NUMBER D2-14934-3

TITLE WS-133A Maintainability Progress Report (U)

MODEL NO. WS-133A CONTRACT NO. AF04(648)-289

ELECTRICAL CABLE CASE  
25-29147

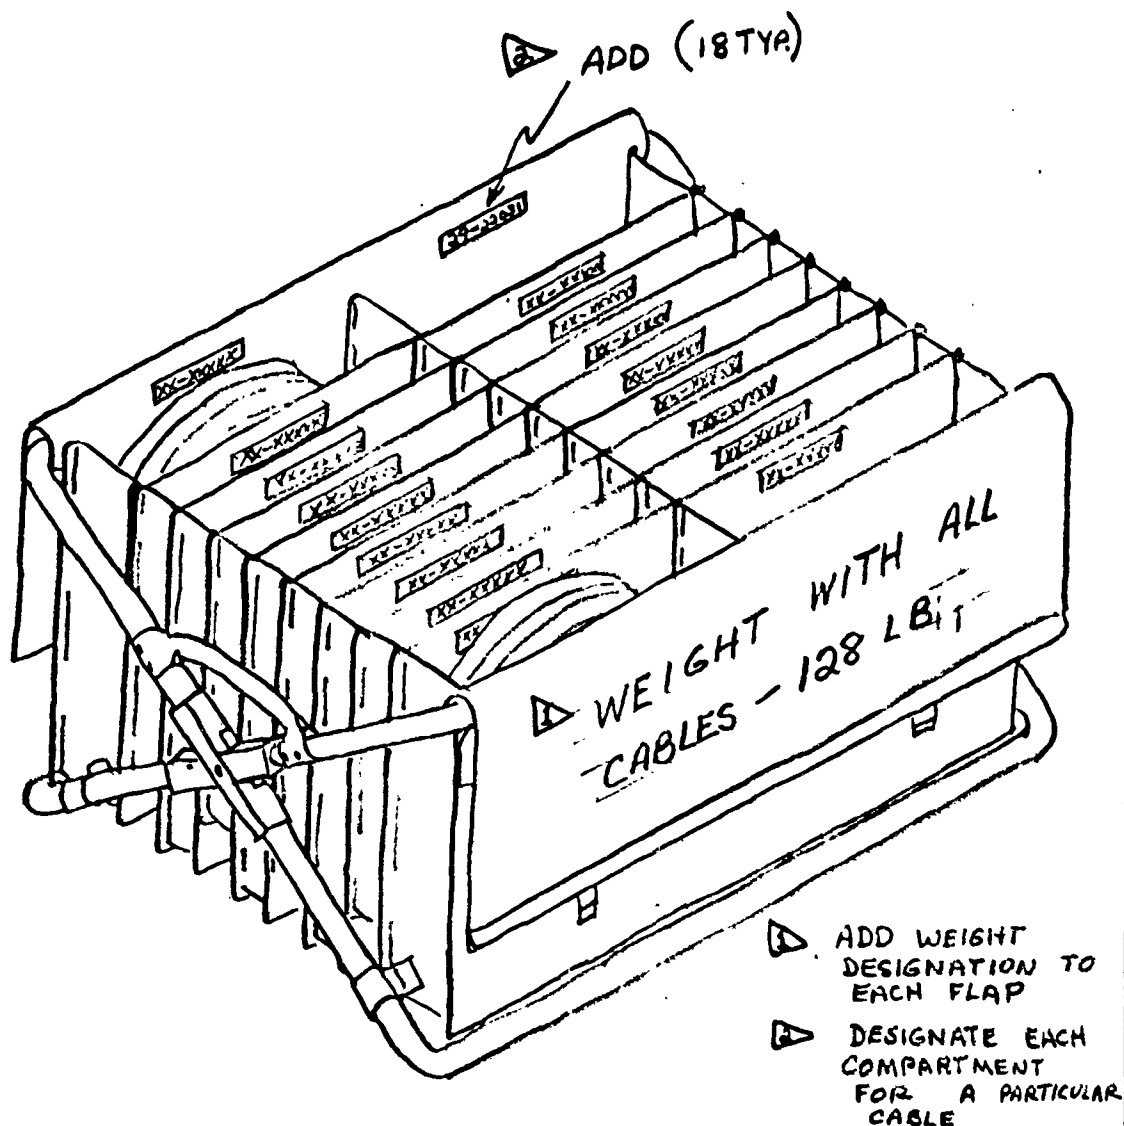
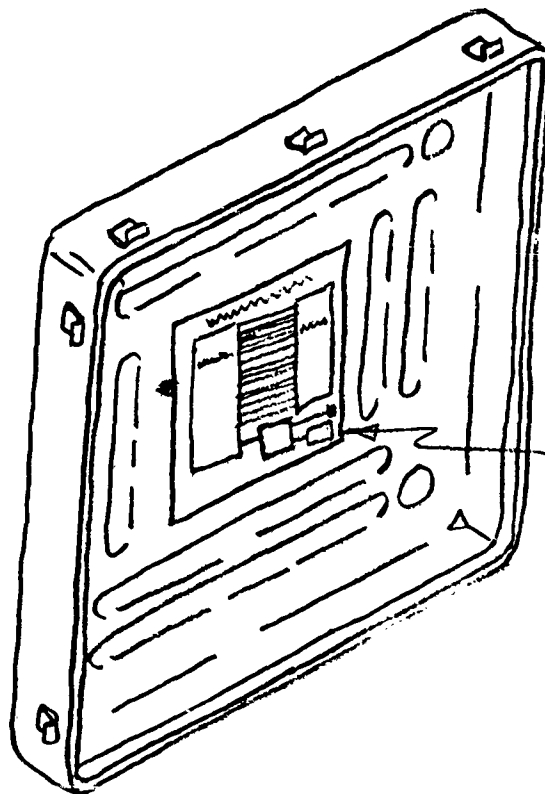
Provide a cable hook-up placard in the Fault Locator and the Distribution Box suitcases. See attachment B.

ADD  
PLACARD SHOWING  
CABLE HOOK-UP  
FOR PROGRAMMER  
GROUP TEST  
SET SELF-TEST  
(REF. T.O. 21-SM80A-23)  
FIG. 2-25
